ADDENDUM 2

PROJECT: MSB Air Distribution 6th Floor

RFP NO: 744-R1716

OWNER: The University of Texas Health Science Center at Houston

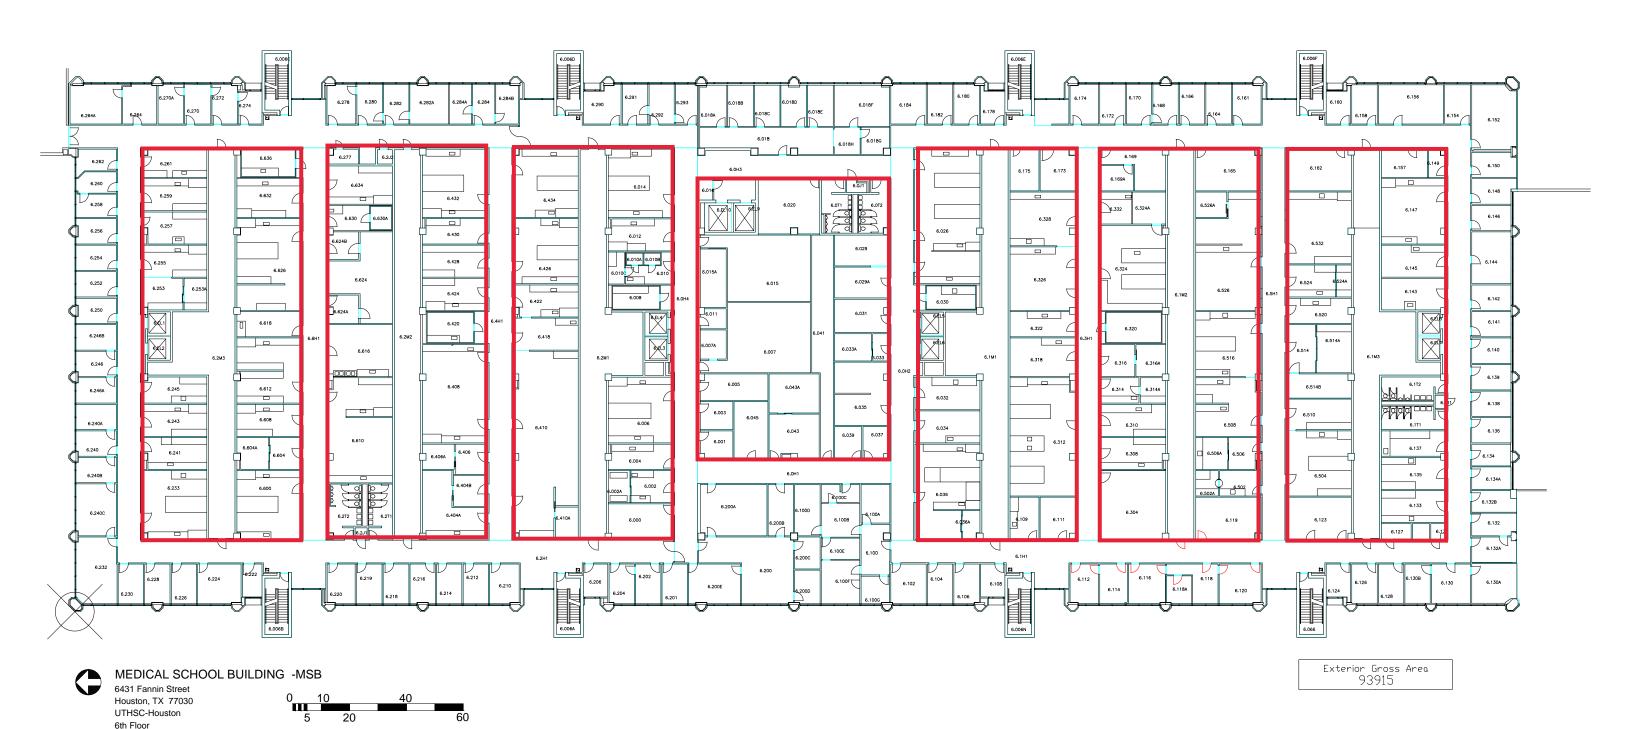
See finish list posted with bid documents for carpet. Lighting motion sensors are integrated into the light fixture.
- 28. Please provide a floor plan indicating where the vinyl wall covering is to be removed/replaced.

See attached drawing.
- 29. Can we be more specific (room numbers) on areas that are covered under <u>Alternate 2</u>: Remove existing wall covering, refinish and paint? I don't see where they are covered, we only have Engineering Drawings, not Architectural drawings. Vinyl is listed under **CARPET** on list with Room numbers.

This is referencing flooring material, not wall coverings. The drawing provided indicates the general area where the vinyl wall coverings are located.
